Loowit Consulting Group, LLC

RE: Addendum to Jackson Villa 4 Project – Chehalis, WA.

Loowit Consulting Group, LLC (LCG) has completed an addendum to the critical areas report for Jackson Villa 4 – Lakewood Investors, LLC – in Chehalis, WA. The purpose of this addendum is (1) address comments from City of Chehalis letter dated June 16, 2021 and (2) document conditions of a seepage area on top of verified fill material in the northern portion of the subject site.

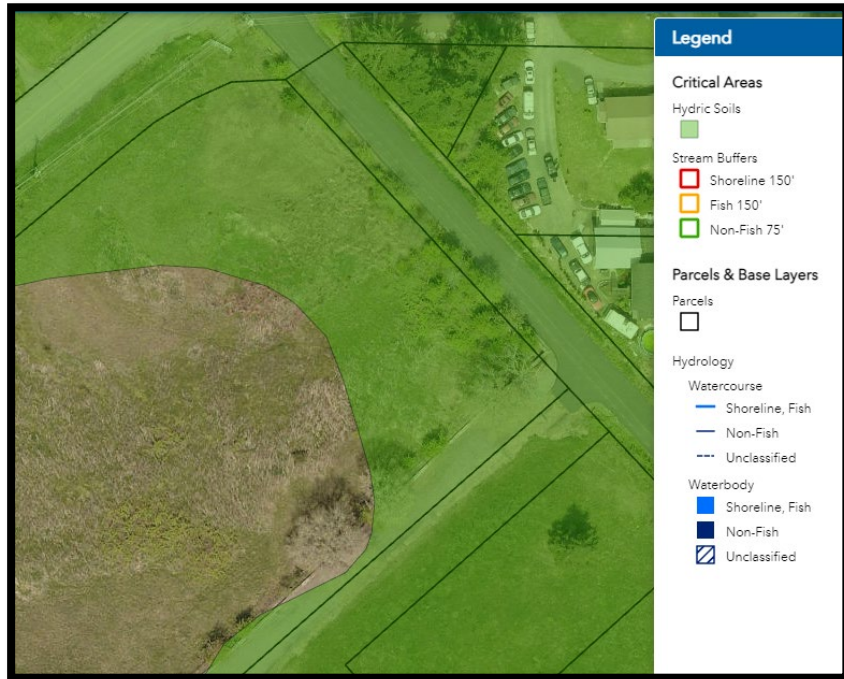
1. "...a 150-foot buffer for a fish bearing stream crosses the southwest corner of the site next to Jackson Hwy." **This comment is in response to review the Lewis County GIS Web Maps including stream courses and buffers as depicted below:**

The Lewis County GIS Web Map stream mapping in the area of the subject site is wrong as depicted in the above edited screen capture. The Type F stream located south of the subject site is approximately 420 feet from the southern boundary of the subject site and buffers associated with this stream do not encroach into the subject site.

Photograph 1: Seepage area on top of document fill material.

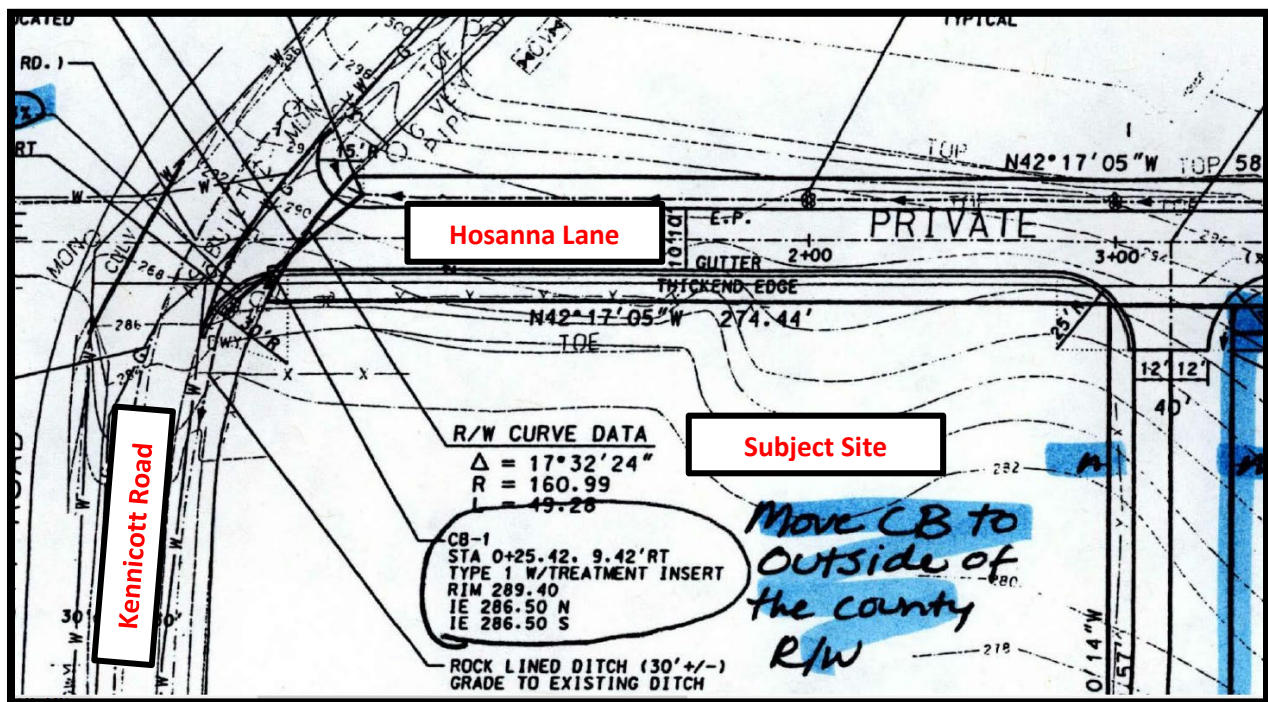
2. "... there was no indication of test pits on the north end of the site or other type of analysis to determine if the hydric soils exist as shown on the Lewis County GIS Web Maps or if they impact this project in anyway." **Conditions in the northern portion are discussed in more depth in the Jurisdictional Determination section of this report. The hydric soils map (below) for the area in and around the subject site is grossly inaccurate and not representative of real world soil conditions in the area.**

The fill material has been well documented by the geotechnical engineers and civil engineers involved with developing the site into residential housing. The fill material is quite diverse including clays, silts, angular gravel, round gravel, boulders, concrete, asphalt, bricks, organic material, cans, bottles, and miscellaneous other debris (Photograph 2).
